Change Order No. 1

Date of Issuance: 9/22/2025
Owner: Town of Bristol
Contractor: Phoenix Fabricators, LLC
Engineer: Jones Petrie Rafinski Corp.
Project: Town of Bristol Water System Improvements

Bristol Water Improvements Contract B
Change Order 1
September 22, 2025

WATER TOWER SITE PLAN (1)
SCALE: 1" = 30' (C101)

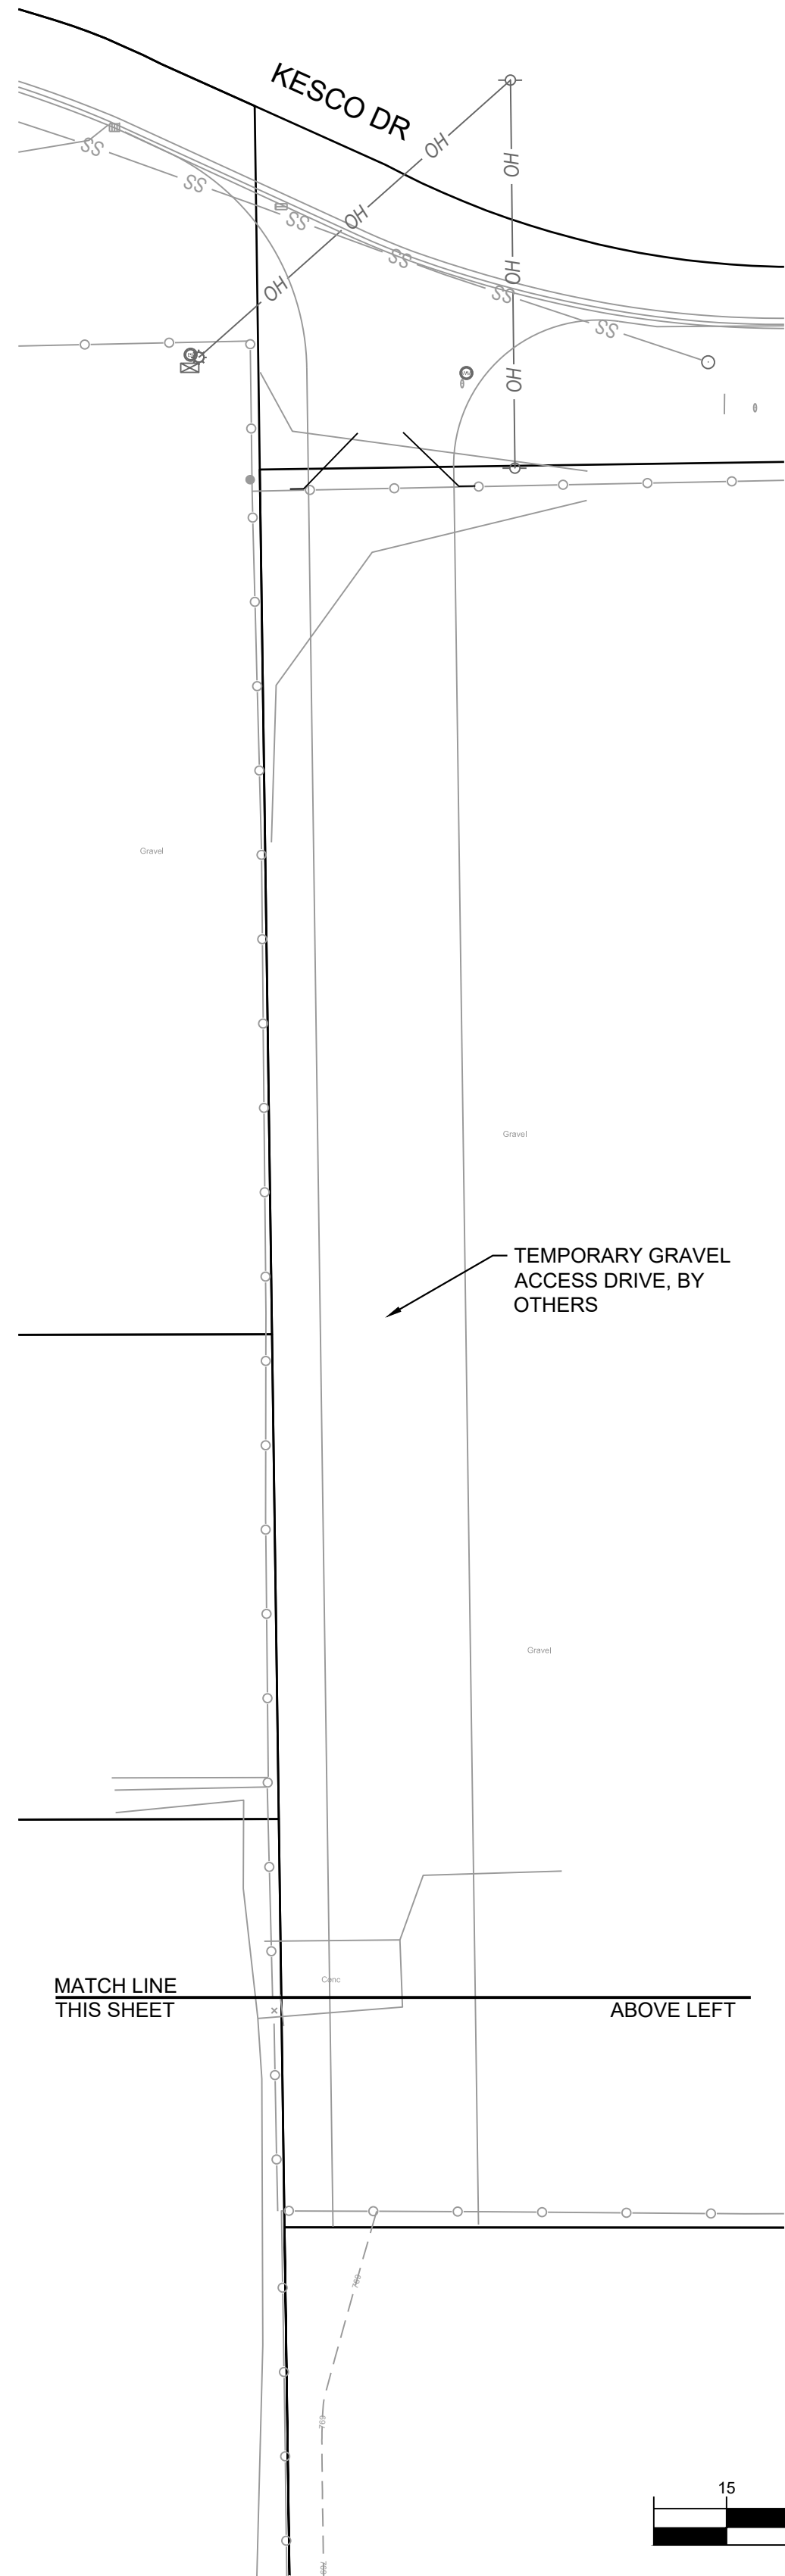
Updates: C101, C103, M104

PLAN & PROFILE - WATER TOWER SITE
STA. 400+00 TO STA. 403+50 - LINE 'A'

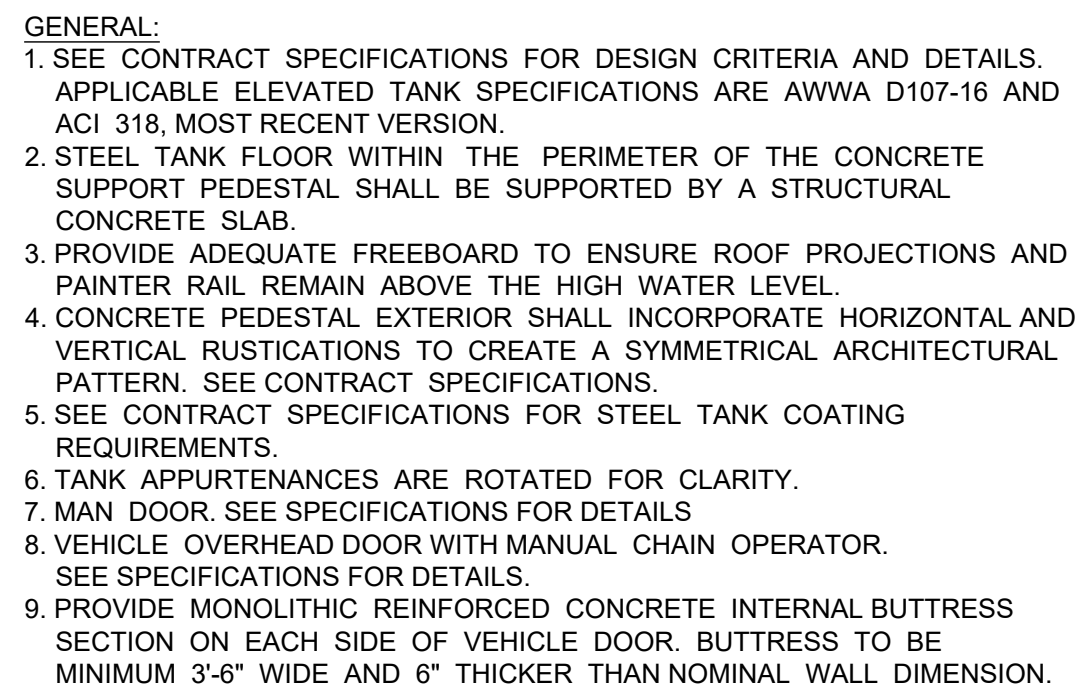
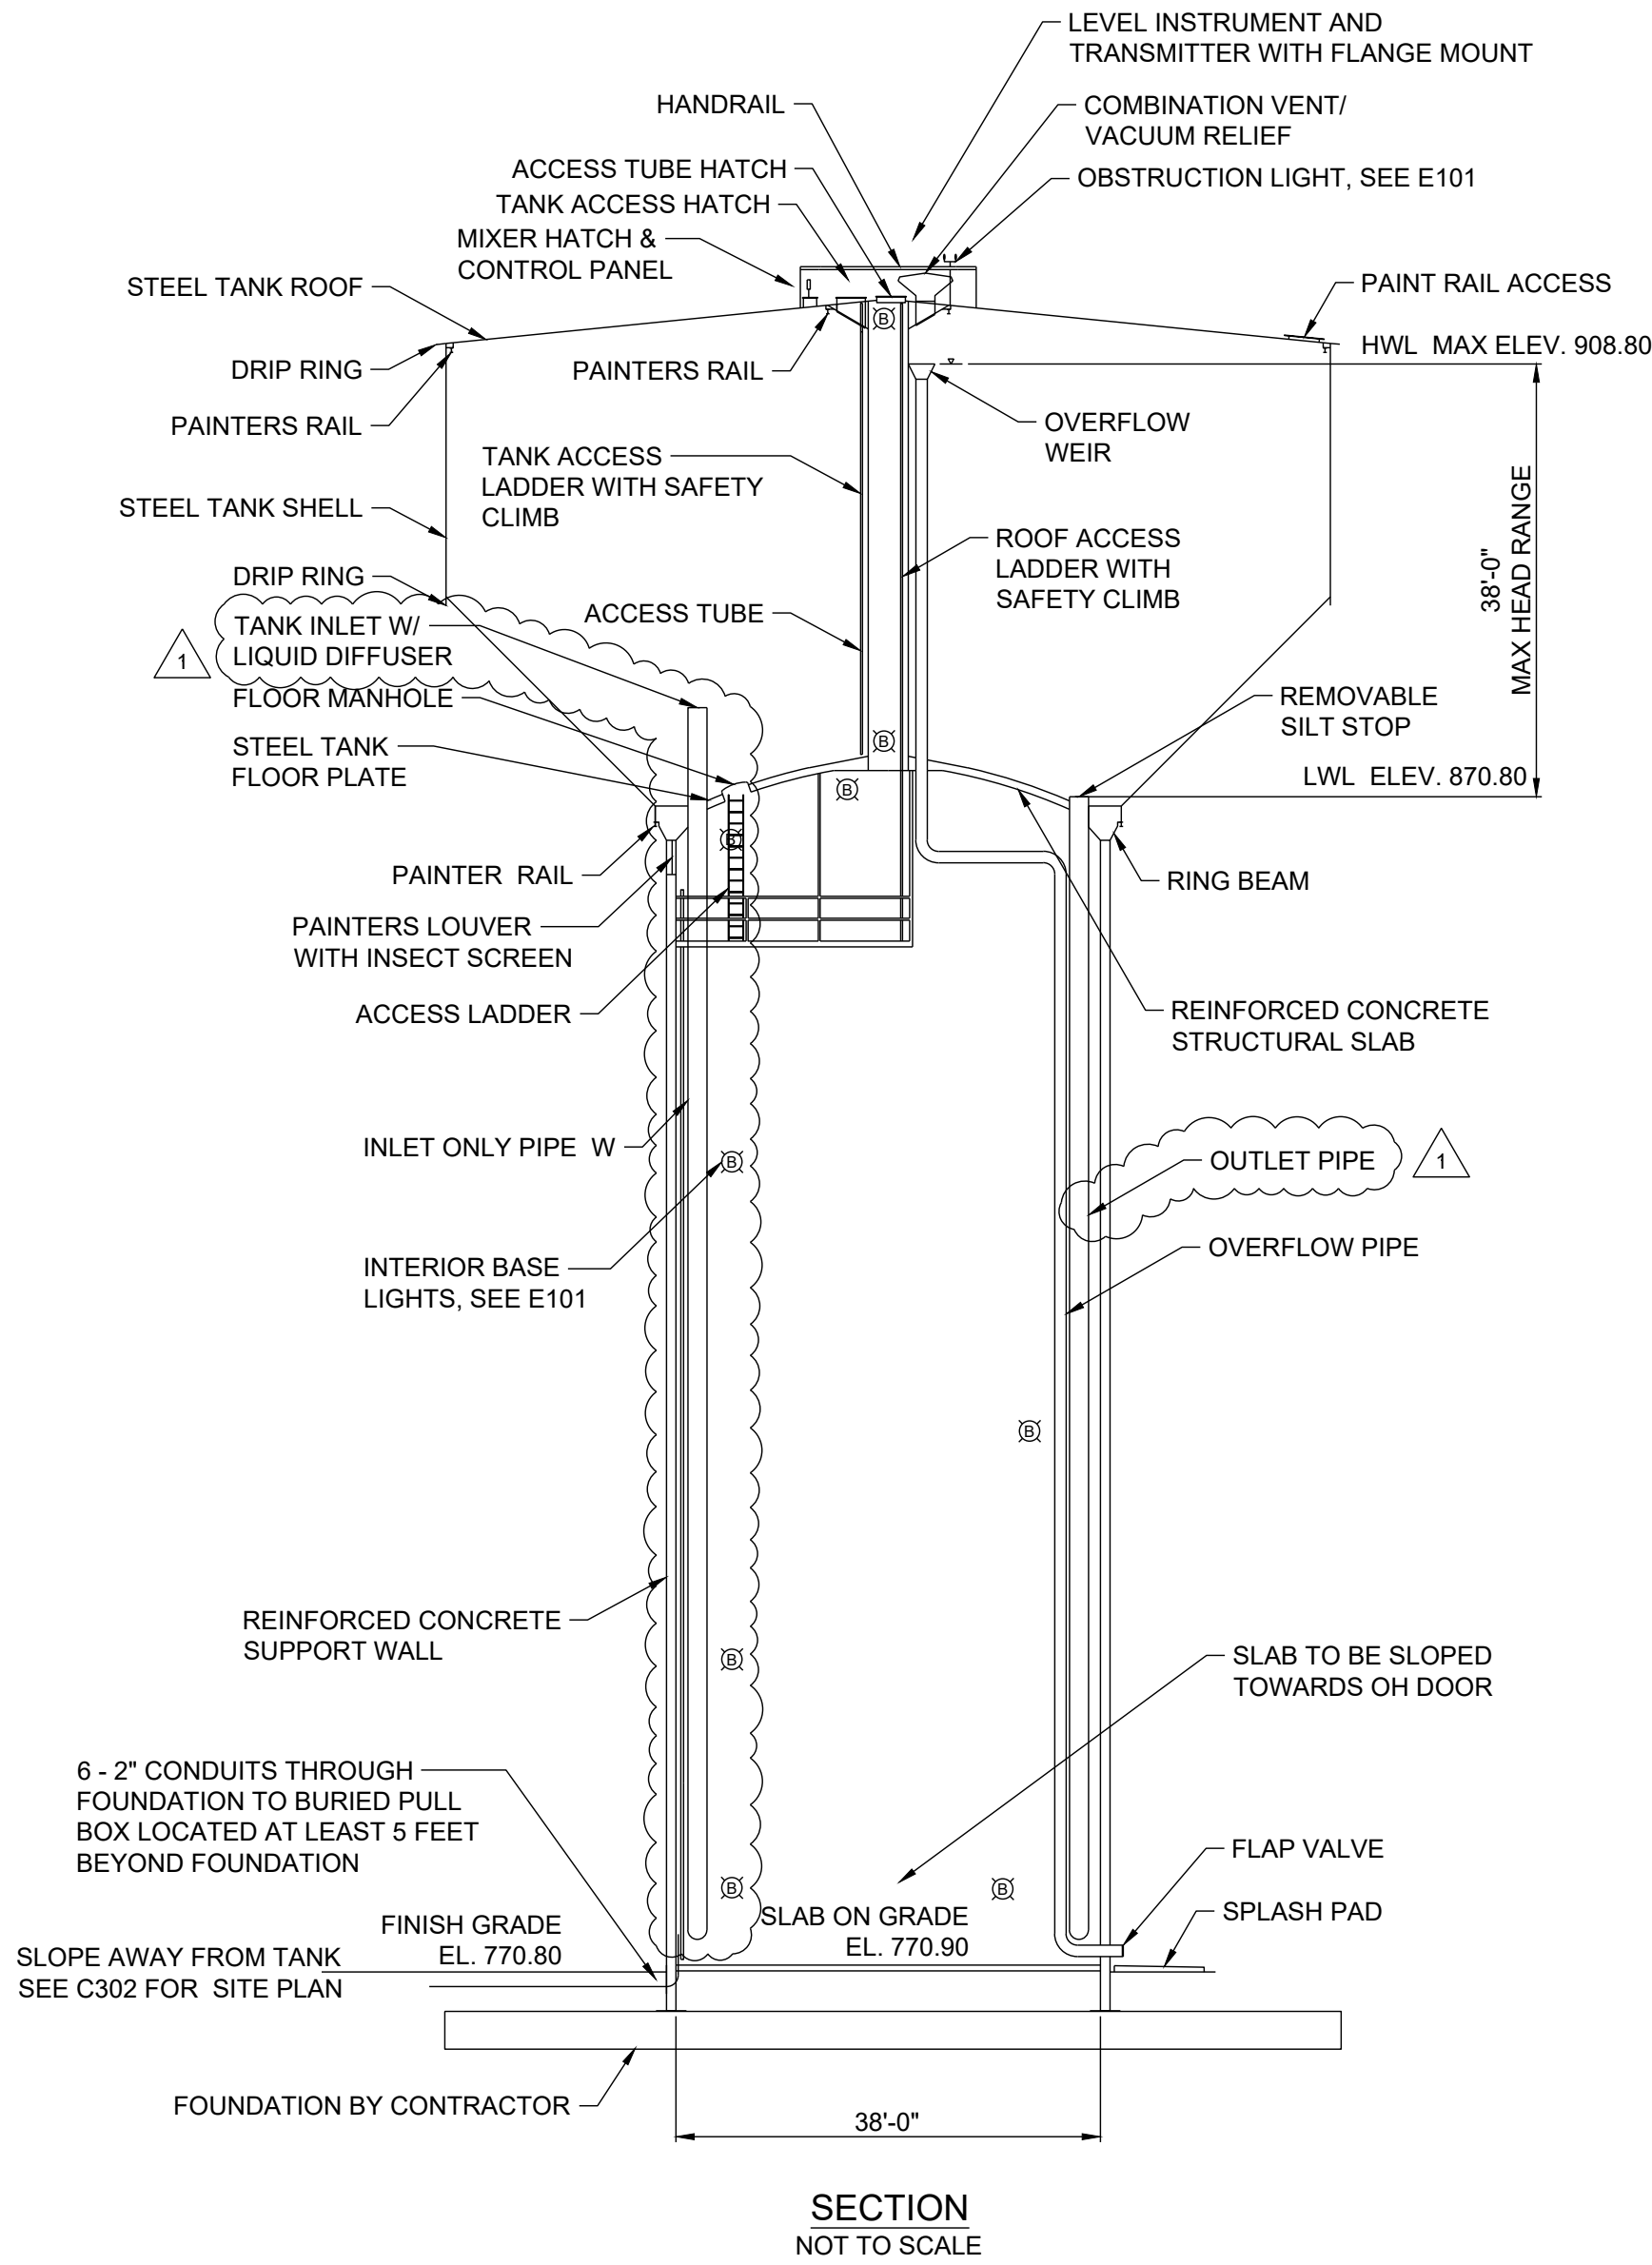
Add: Line B on C103A, M102

Credit: C103: 10 LF and 2 45s in yard due to the pipe alignment change

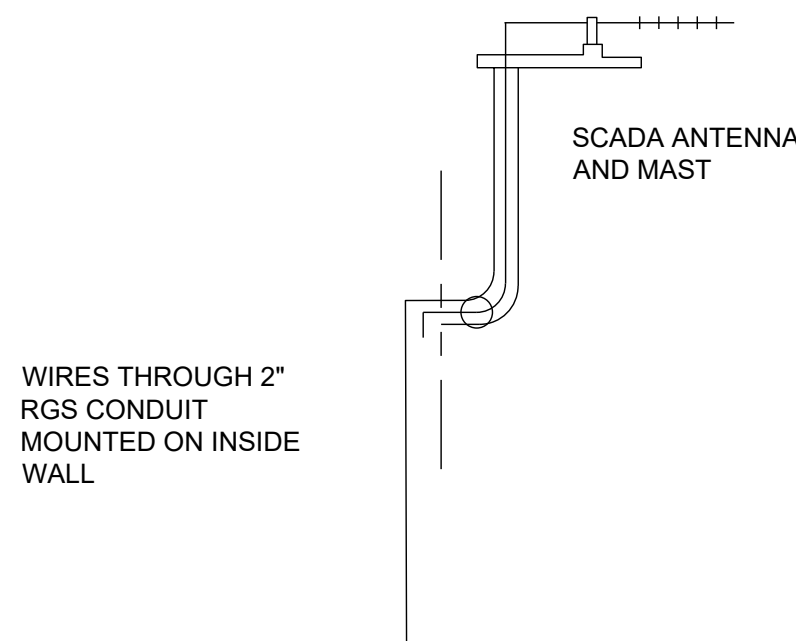
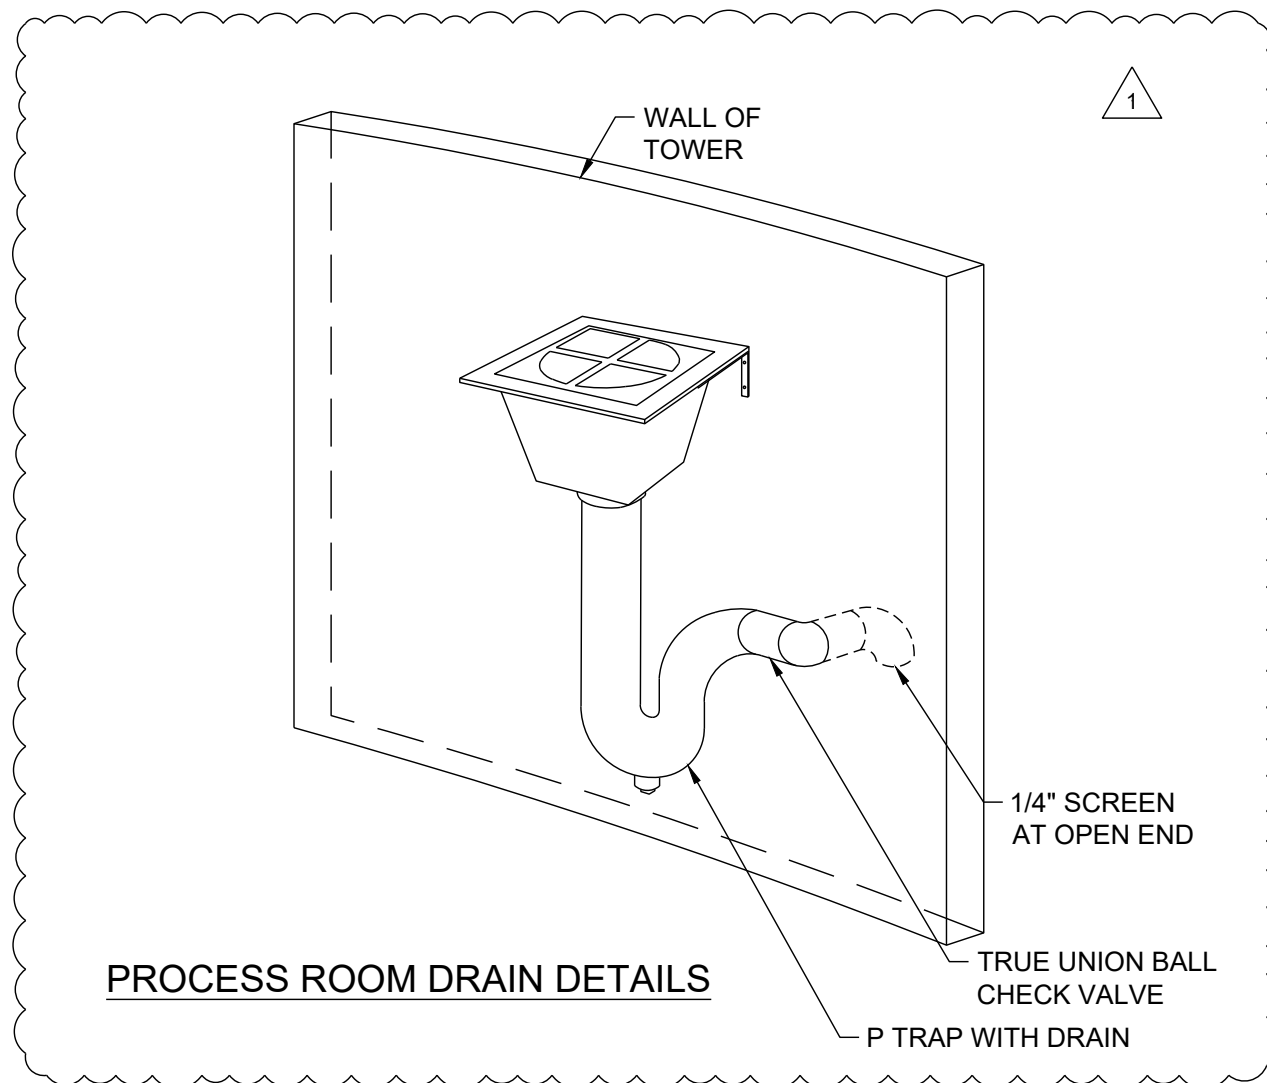
1. Level Monitoring on Top of the Tank, LIT-TANK

- a. LIT Rosemount 5408, or equal, flanged, with local display and 4-20mA output.
- b. Tank Manufacturer to include a port with flange on the top of the tank within the handrail.
